Builder Site Audit

Sample Project – Lot 12

Prepared For Sample Builder Co.

ELECTRICAL Raised by: RW 9/10

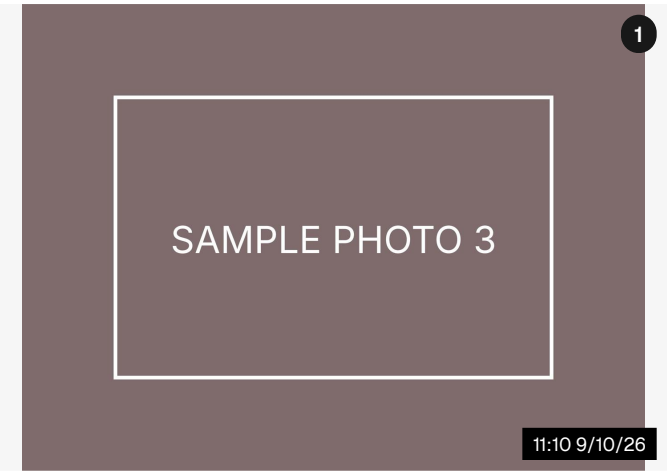
No outlet rough-in on the island wall. Outlet required by plan.

FRAMING Raised by: RW 9/10

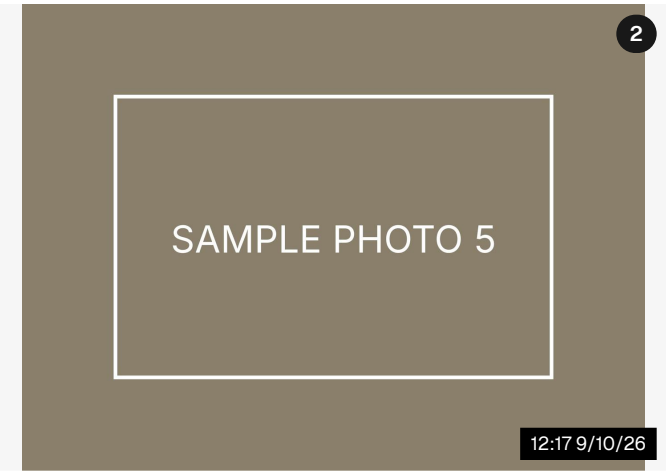
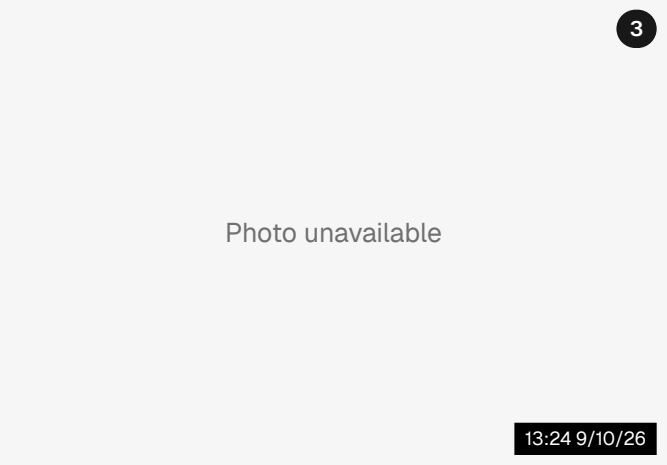
Wall bowed about 3/4 in. at the pantry. Shim or re-frame so the tall cabinet sits plumb.

Completed 9/11

WINDOWS Raised by: RW 9/10

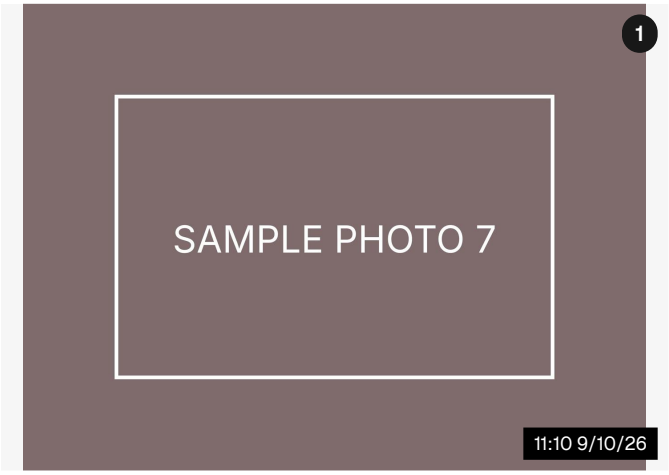
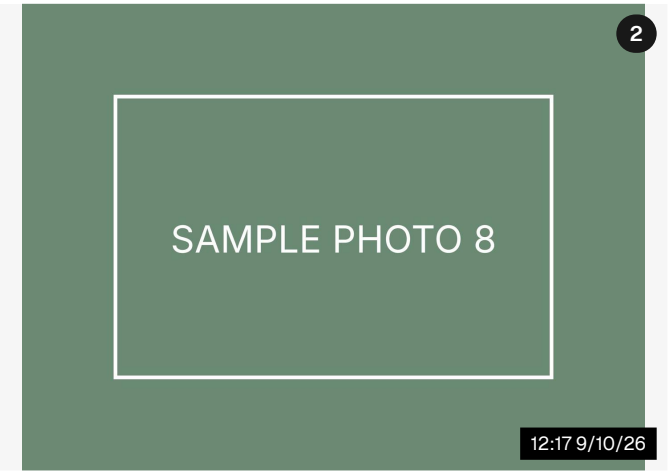
Window sill is lower than the tub deck. Confirm height with the builder before the surround is ordered.
